Plan & Architectural Review Meeting

Monday, August 12, 2024 - 6:00 PM

- 2. Discussion and possible approval of a Conditional Use Permit and Site Plan Review for a multifamily development located on vacant land at the corner of Moraine View Parkway and Jakes Way Tax Parcel # /WPB 00044.

To: City of Whitewater Plan and Architectural Review Commission

SITE PLAN C1.0

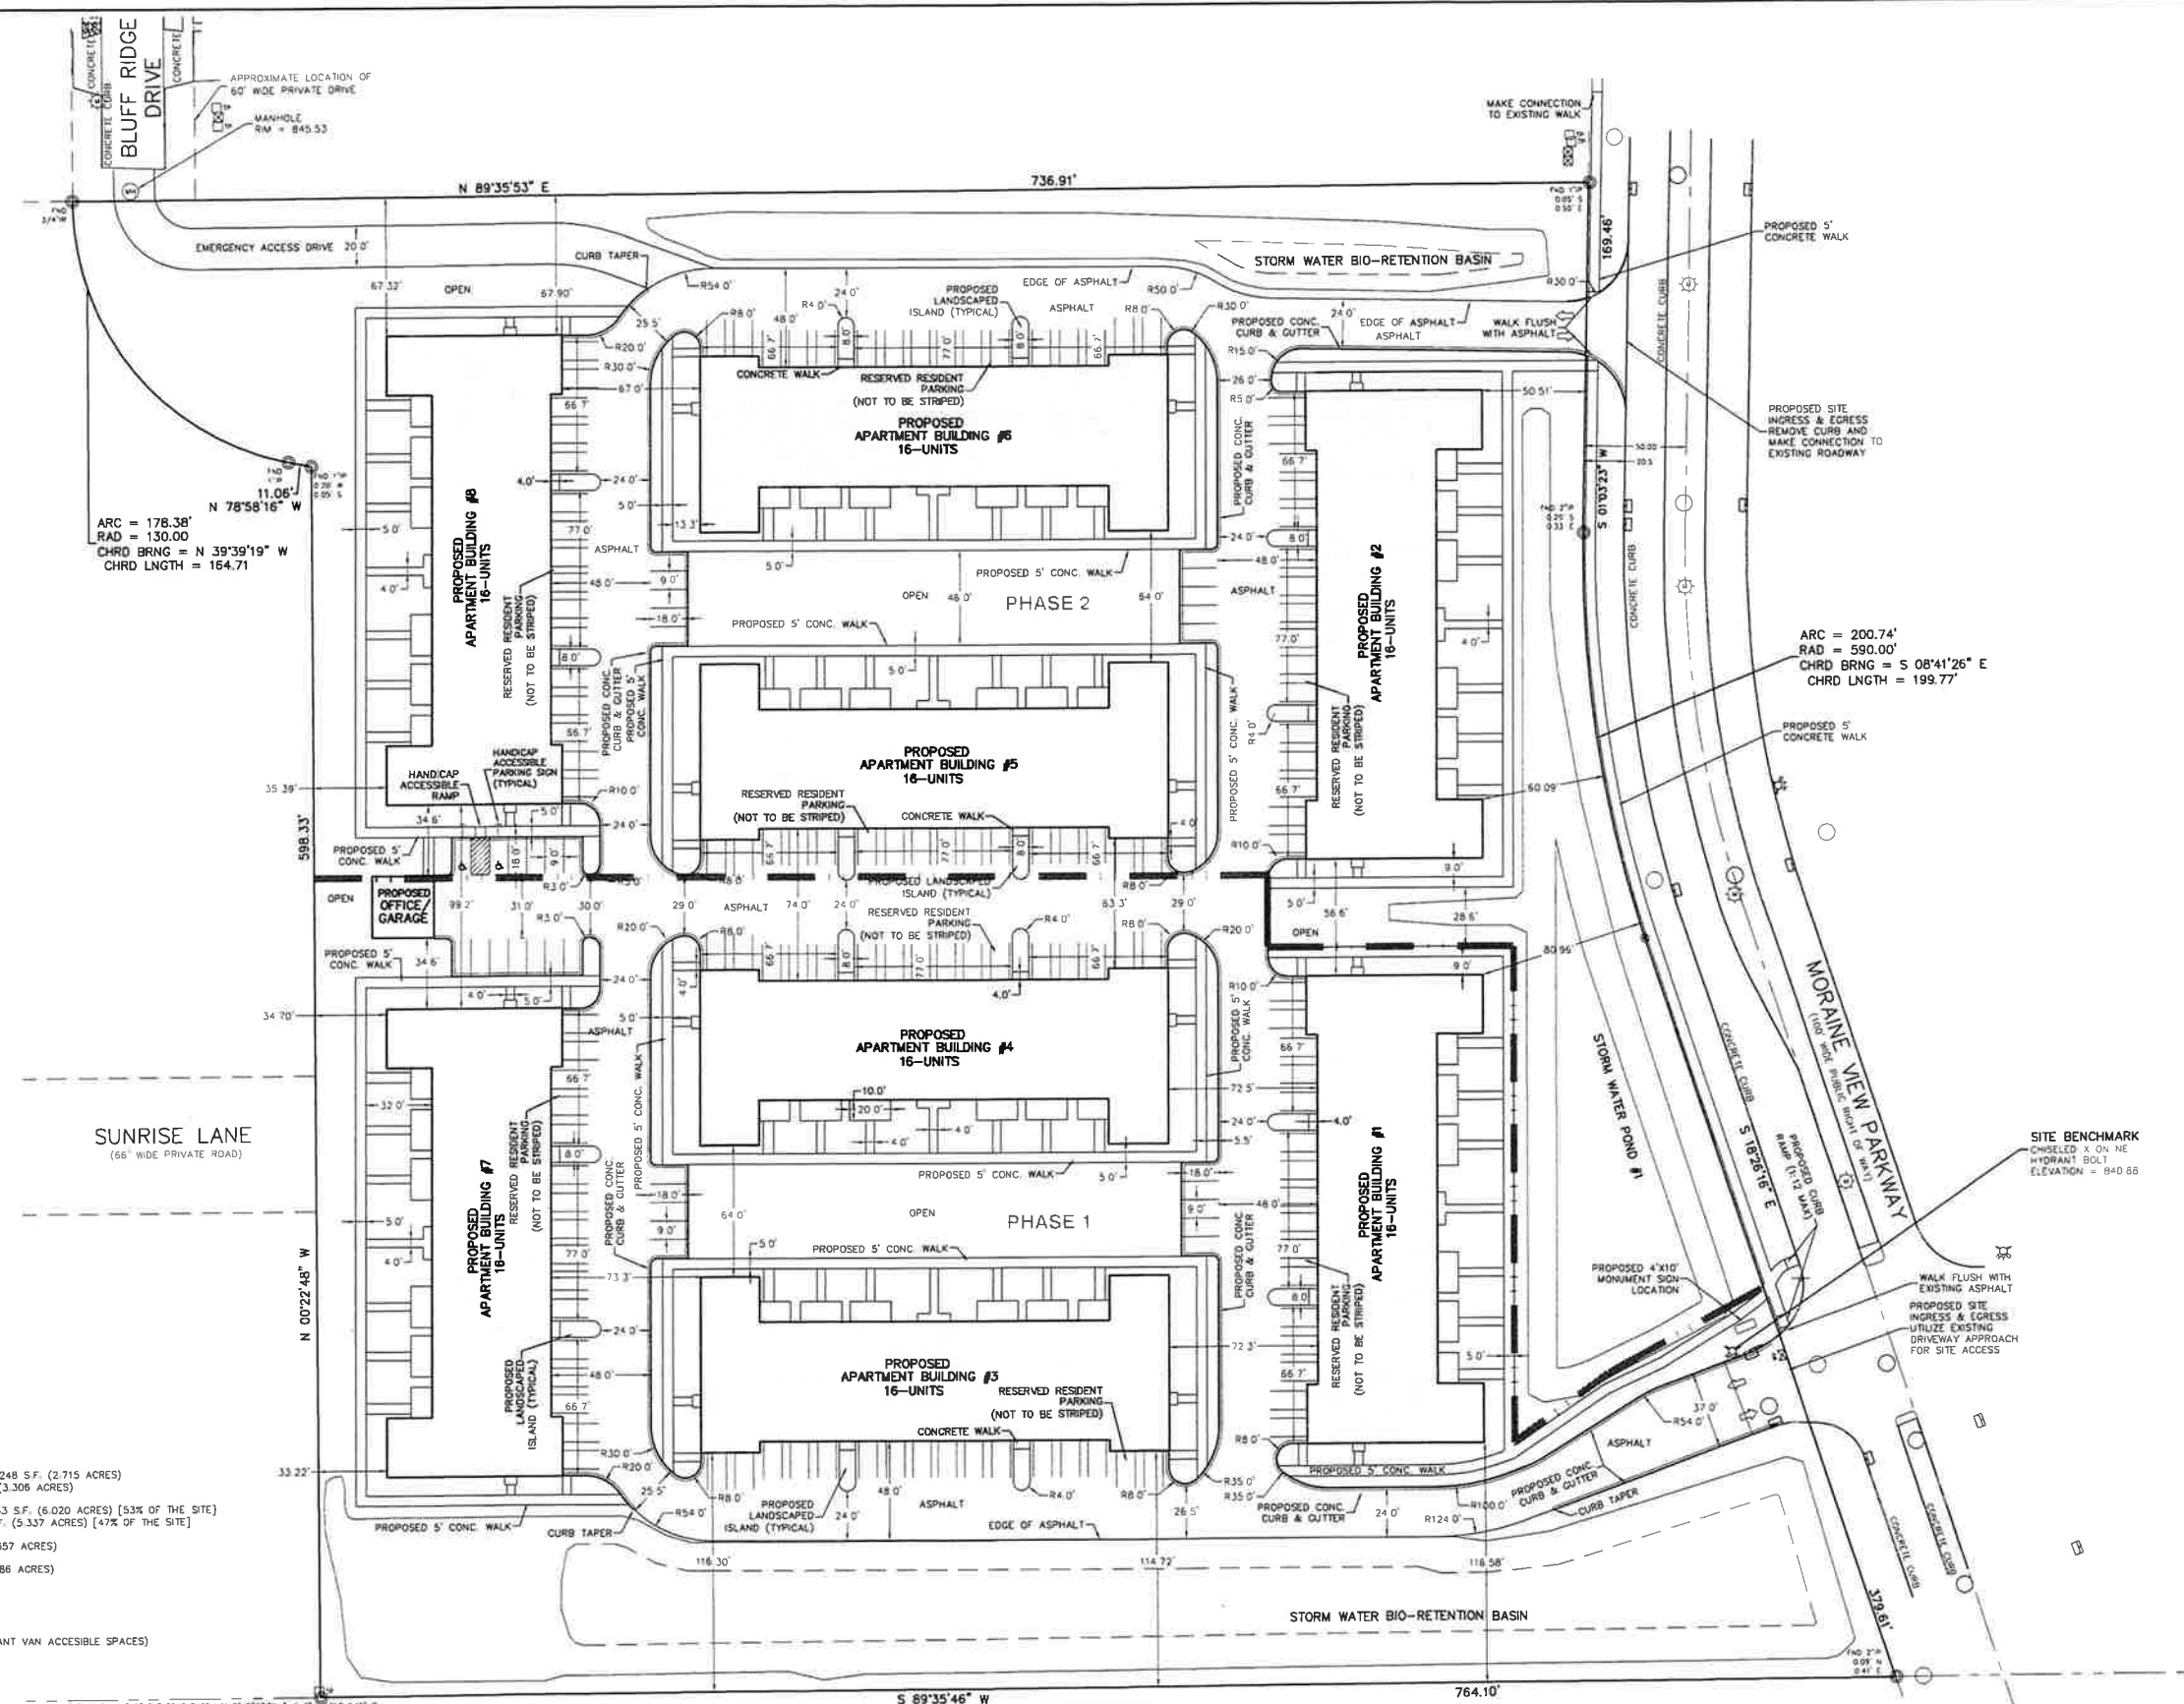
- Parking:
 - While the current site plan includes two parking spaces per unit (between the garage and driveway), this may be insufficient for three-bedroom apartments, and for visitors. Please consider the addition of an overflow parking location on-site that could be utilized.
- Recreation:
 - Due to the site plan not including a playground/recreation area, it is recommended to ensure there is sidewalk connecting the entire development along the public right of way for access to Walton's East Gate Park. Safe and convenient access to recreational areas is important for the community.

Site Access: While the current plan includes two ingress/egress points off of Moraine View, which meet the required width per code, we believe that extending Bluff Ridge Drive to the south would enhance emergency vehicle access. This third avenue of approach would facilitate efficient operations and provide an additional route for our apparatus.

Turning Radius: We have noted some challenges for our larger apparatus to make the turn near buildings 1 and 2 upon entering the development. To address this, we suggest widening the main approaches or adjusting the curb/walkways by a few feet. Similarly, adjustments at the entrances for garage access to buildings 4 and 5 would improve accessibility. We believe these modifications can be easily discussed and implemented with the developer.

- H. All police comments or concerns be addressed.
- I. All fire department comments or concerns be addressed.
- J. Sidewalks be added to the site for connections to Moraine Parkway.
